MINNESOTA PLUMBING BOARD ORDER GRANTING VARIANCE

Re: Request for Minnesota Plumbing Code Variance Xcel Energy St. Paul Service Center TKDA Project No. 0014963.067

Xcel Saint Paul Service Center – Variance Petition

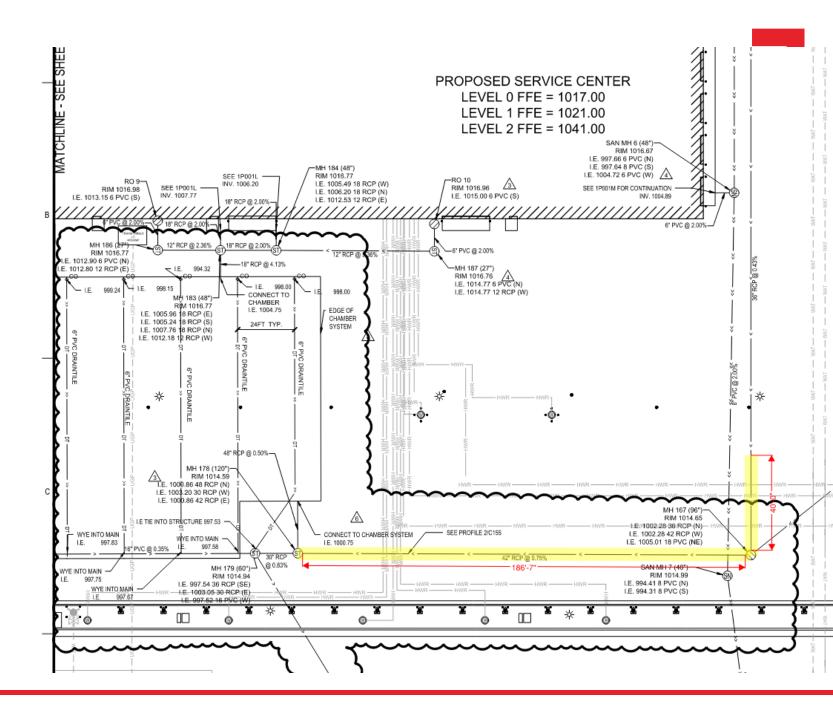
- 2020 Minnesota Plumbing Code, Section 310.5, Obstruction of Flow.
- Key Points
 - The original design of the storm sewer pipe and stormwater filtration chamber system for this project met the code for the Water Quality Event (all 3 definitions further described in these slides).
 - During construction of the stormwater chambers the contractor encountered an unforeseen and unexpected condition. The groundwater level is at an elevation higher than expected. The ground water elevation is 3.5 feet above the bottom of the chamber system.
 - Therefore, the chamber system needs to be revised by raising it above the groundwater level, a vertical distance of 3.75 feet.
 - This revision will result in temporary surcharging pipe upstream of the chamber system.

- The surcharged pipe is temporary. The stormwater filtration chamber system will draw down in 48 hours, through filtration, and drain the water in the surcharged pipe. The surcharging is limited to pipes directly upstream of the chamber system.
- No water will surcharge any pipes at the proposed building in any rain event up to and including the 100-year event.
- The surcharging is a temporary condition. However, the request for a variance is permanent.
- Alternatives for construction were considered with the Geotechnical Engineer to keep the system at its current elevation with the ground water, but it was determined to be infeasible due to:
 - The amount and flow of the ground water.
 - The clay soils and limited pumping options.
 - Soil Instability.
 - Constructability and durability of the system liner within groundwater.
 - Buoyancy concerns during construction.

SURCHARGE BASED ON VOLUME

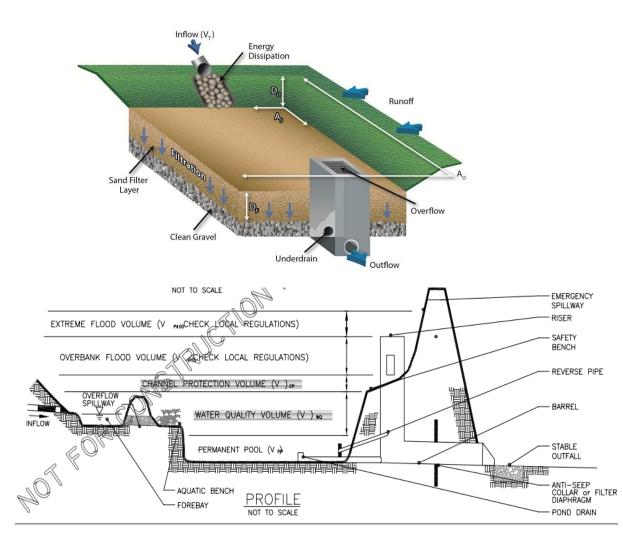
DOLI Water Quality Volume

- 65,340.30 CF
- Elevation= 1002.45

SURCHARGE BASED ON VOLUME

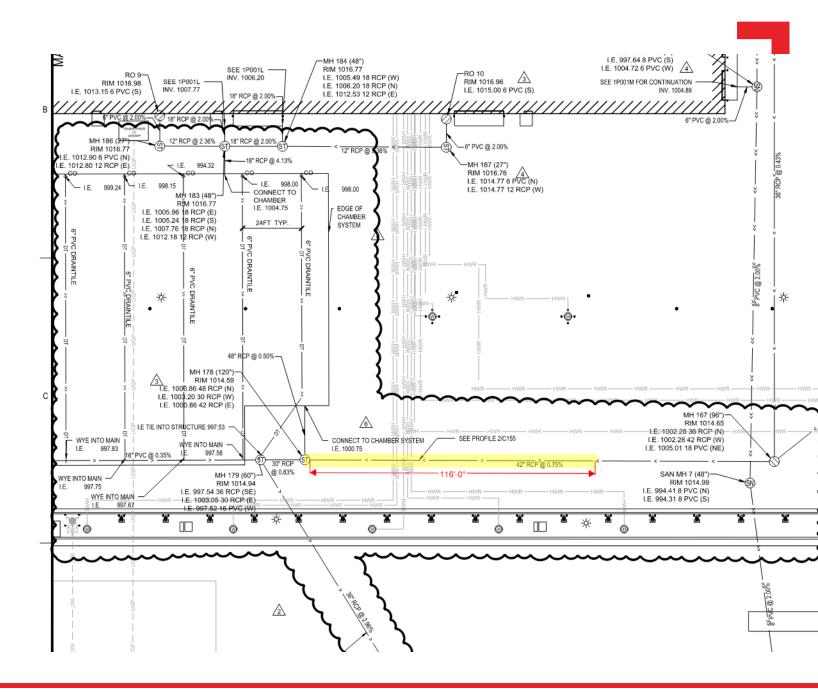
MPCA Water Quality Volume

- 43,596.30 CF
- Elevation= 1001.73

SURCHARGE BASED ON VOLUME

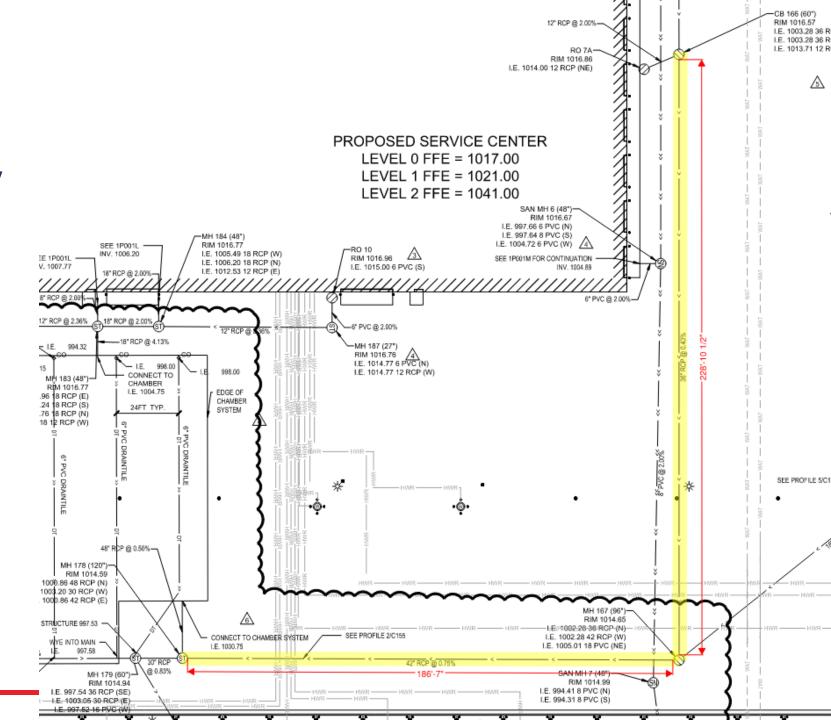
Watershed and City Water Quality Volume

- 89,000 CF
- Elevation= 1003.20
